Subject: Class 1 Permit Modification Notification, Waste Isolation Pilot Plant Hazardous Waste Facility Permit Number: NM4890139088-TSDF

- Completion of Panel 8 Mining

Class 1 Permit Modification Notification

Completion of Panel 8 Mining

Figure D-4
Underground Escape and Evacuation Map

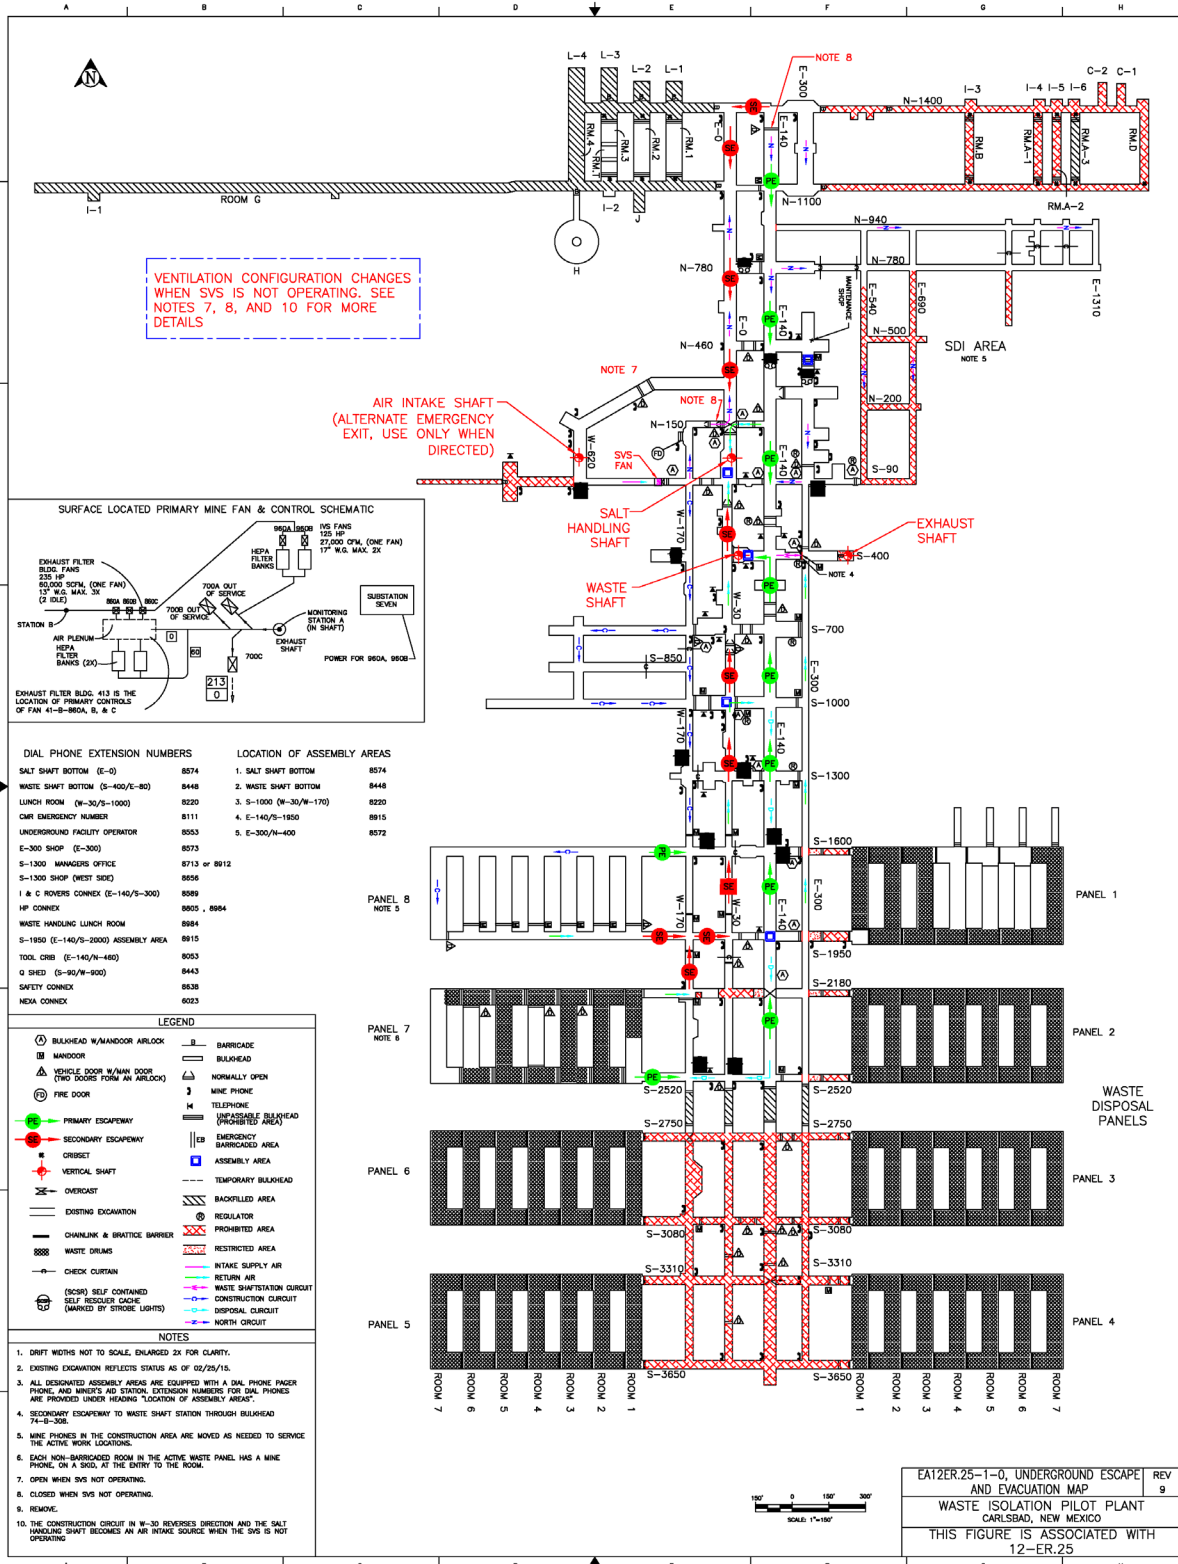
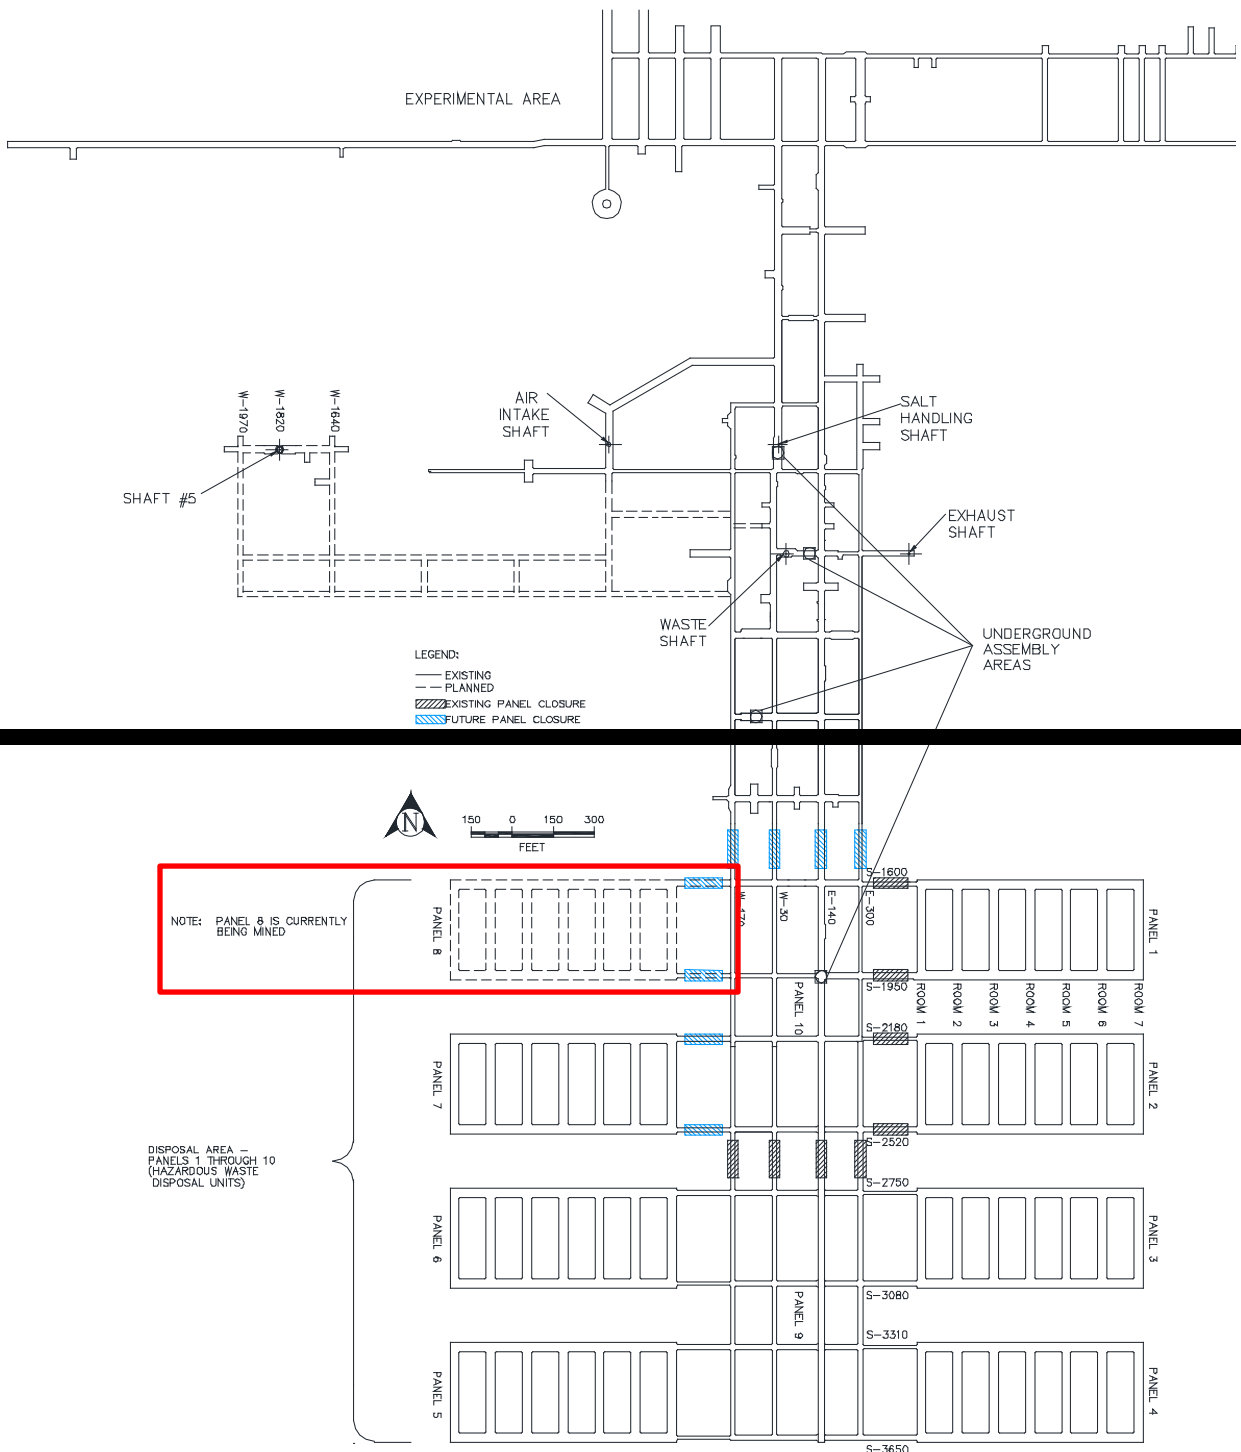
- Permit Attachment D, Figure D-4, *Underground Escape and Evacuation Map*
 - Updated with the most current map from the *Underground Escape and Evacuation Plan* on file at the WIPP facility, which indicates that the construction of Panel 8 is complete.

Figure D-7
Designated Underground Assembly Areas

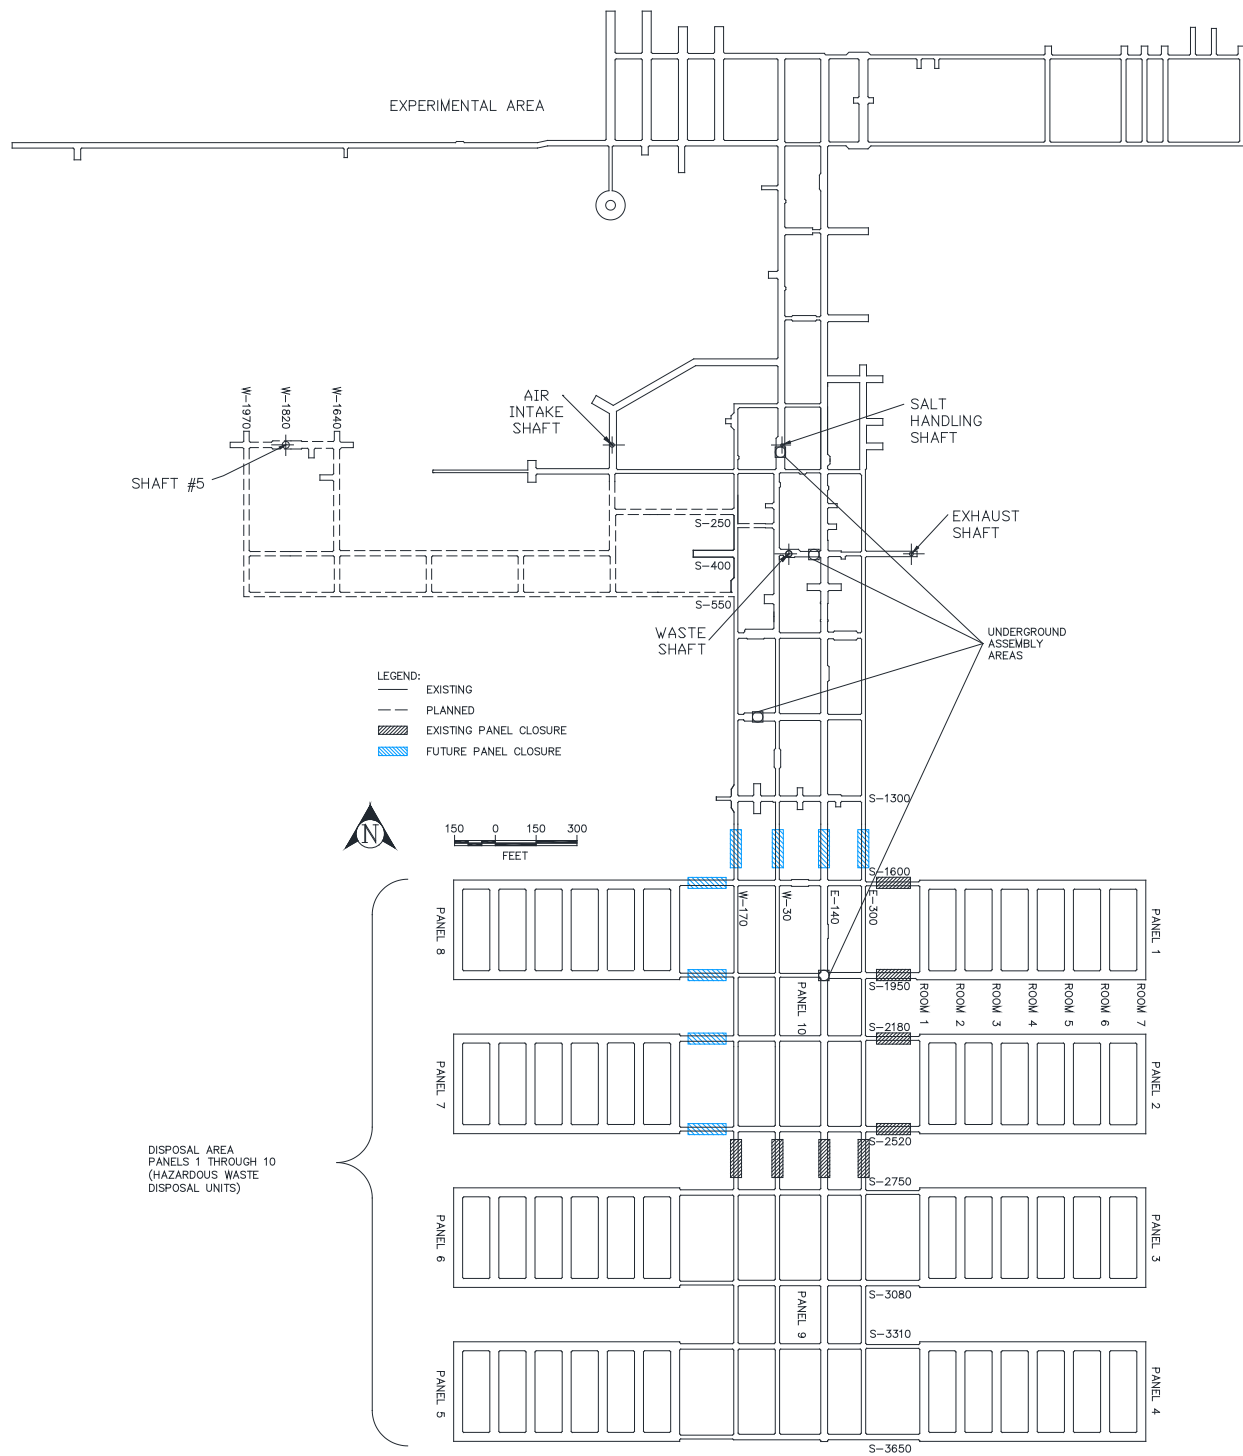
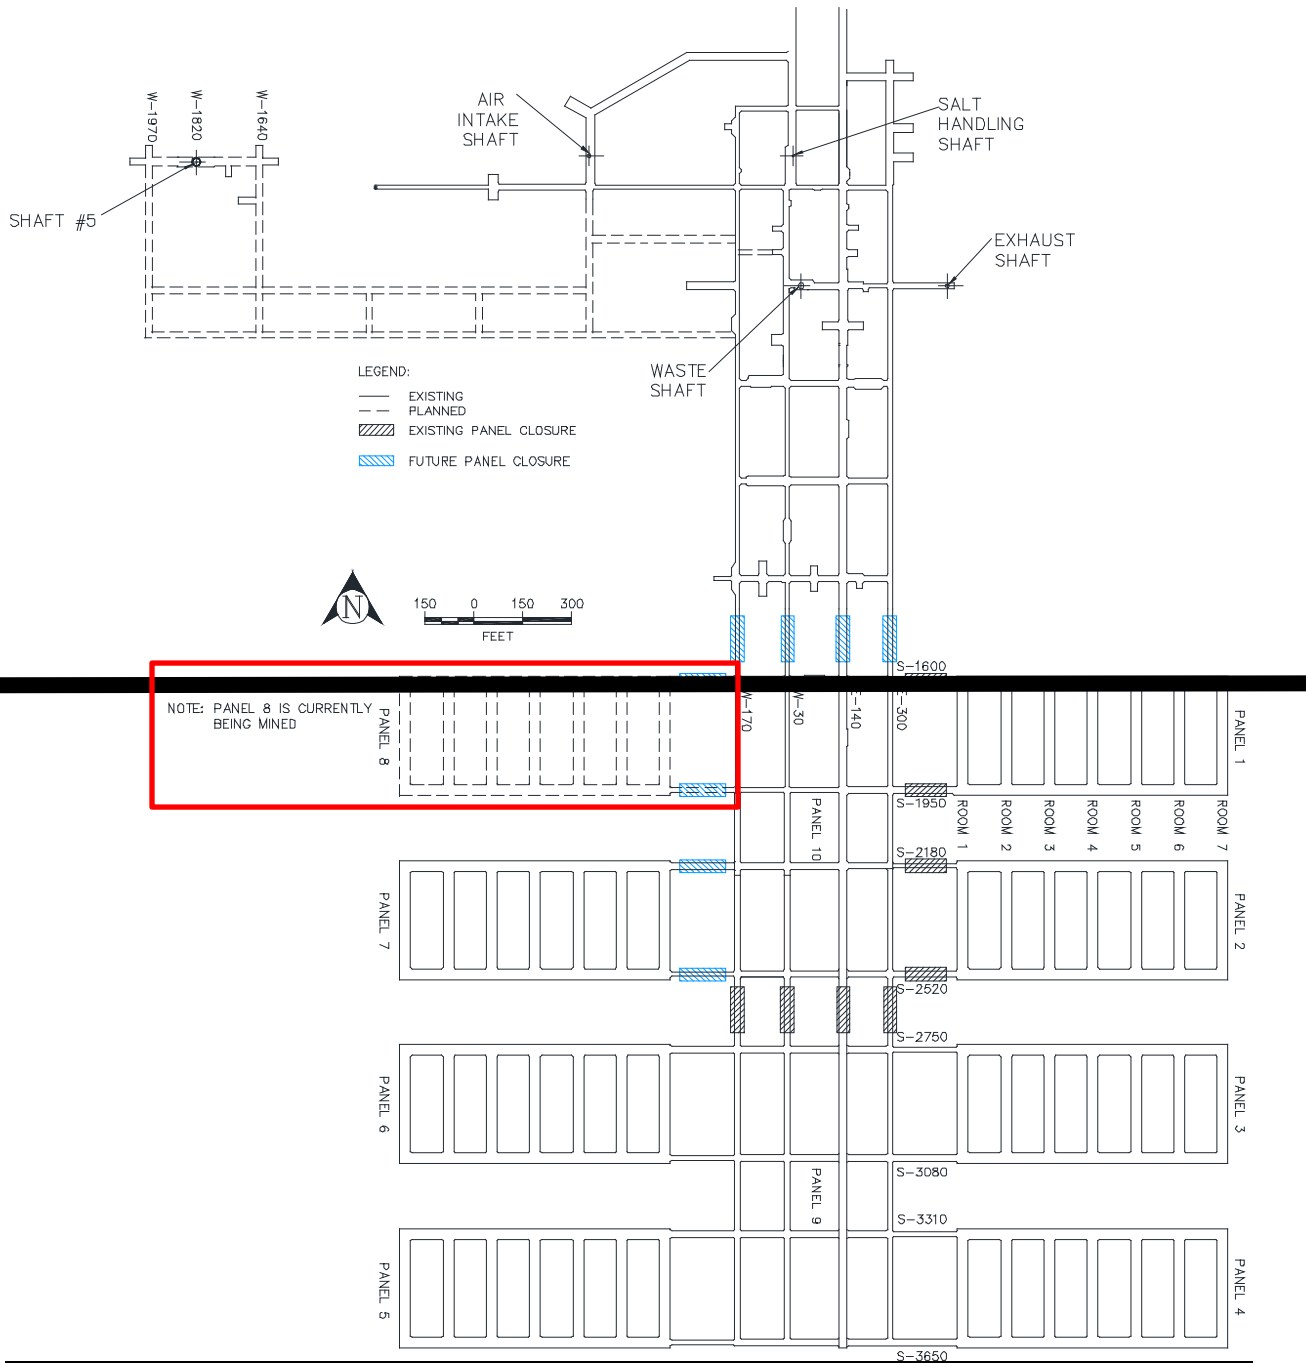
- Permit Attachment D, Figure D-7, *Designated Underground Assembly Areas*
 - Changed Panel 8 dashed lines into solid lines.
 - Deleted the following figure text: “NOTE: PANEL 8 IS CURRENTLY BEING MINED” because Panel 8 status has changed from planned to existing.

Figure G-1
Location of Underground HWDUs and Anticipated Closure Locations

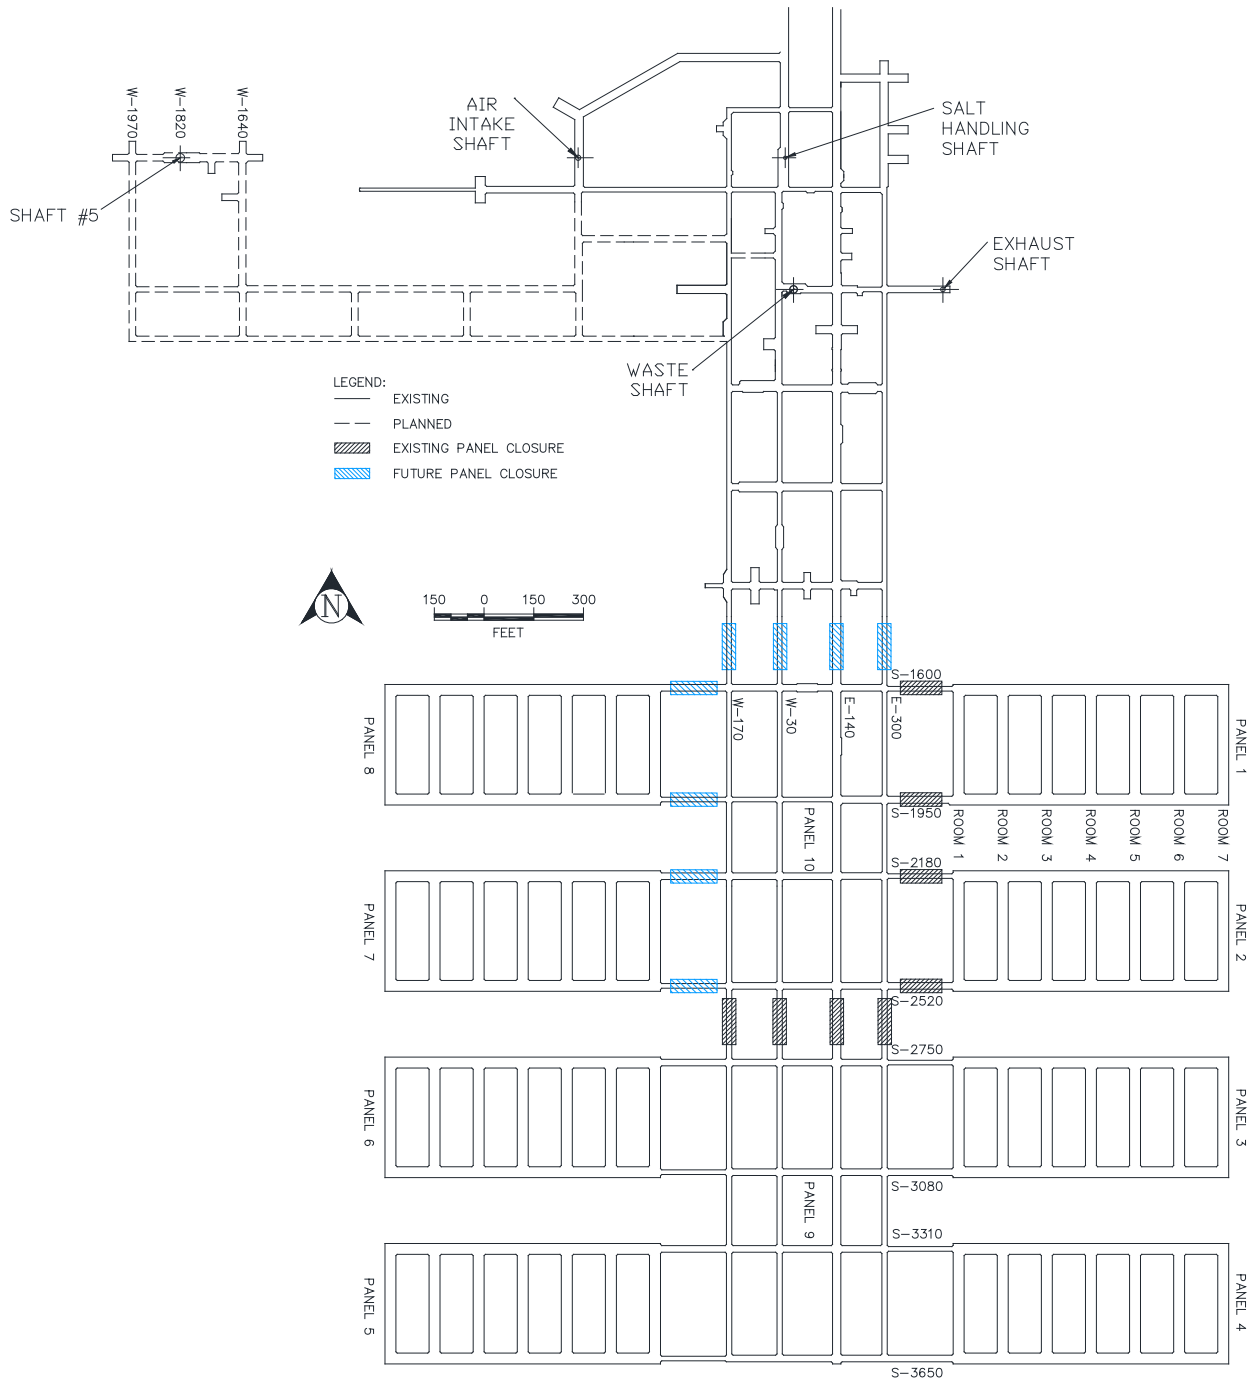
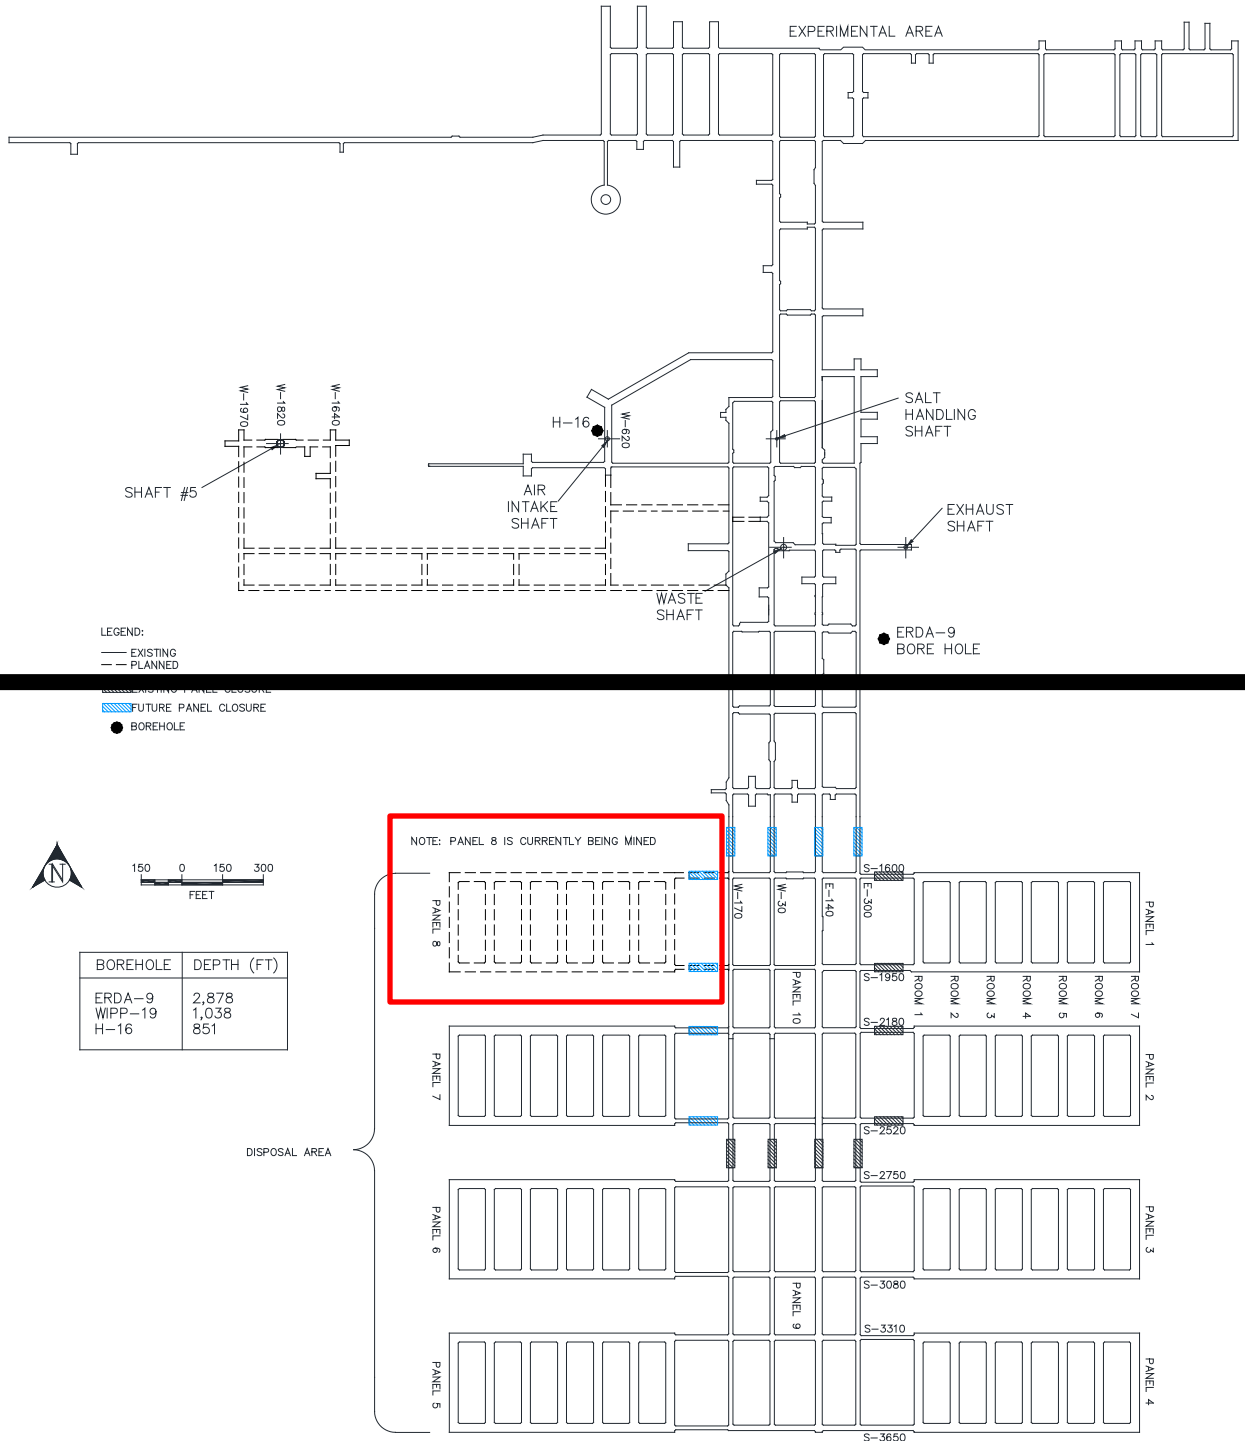
- Permit Attachment G, Figure G-1, *Location of Underground HWDUs and Anticipated WPC Locations*
 - Changed Panel 8 dashed lines into solid lines.
 - Deleted the following figure text: “NOTE: PANEL 8 IS CURRENTLY BEING MINED” because Panel 8 status has changed from planned to existing.
